Carlos Leather Fashion Ltd. (Extension)

Teknogpara, Joydebpur, Gazipur
(24.003962, 90.386709)
3 October 2023

Observations

TABLE OF CONTENTS

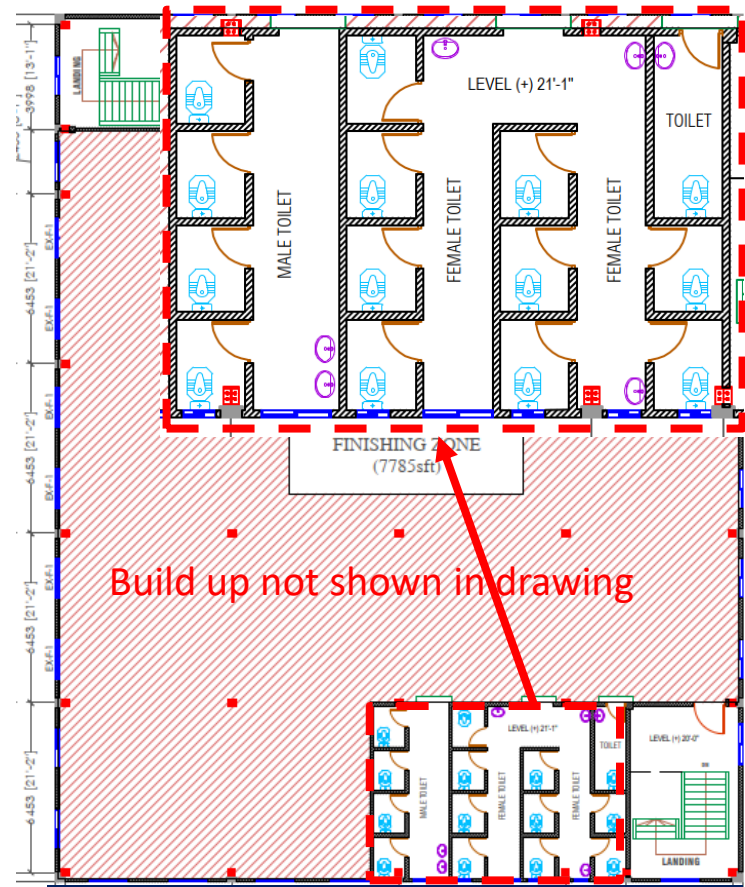
Slab adequacy check, connection adequacy check, earthquake load check are not provided in design report. Building engineer is required to revised the design report including all requirements in compliance with BNBC-2006 (section 1.9.1 of part-6).

Slab adequacy check, connection adequacy check, earthquake load check not provided in design report

Second floor plan

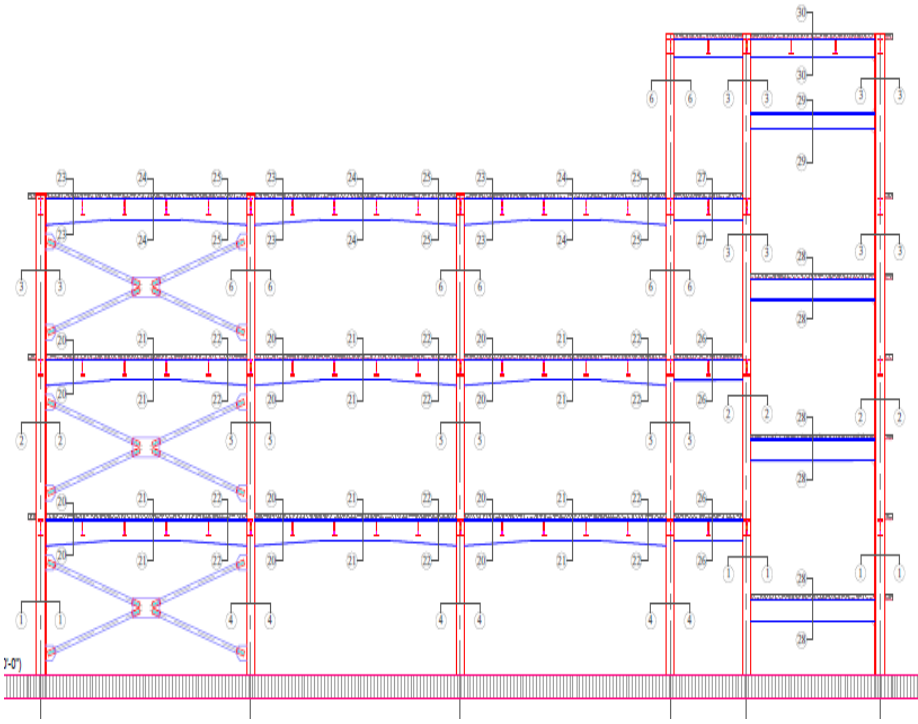
300 mm Build up found at toilet area

Build up not shown in drawing

300 mm Build up was found at toilet area. Building engineer is required to update the as-built drawing.
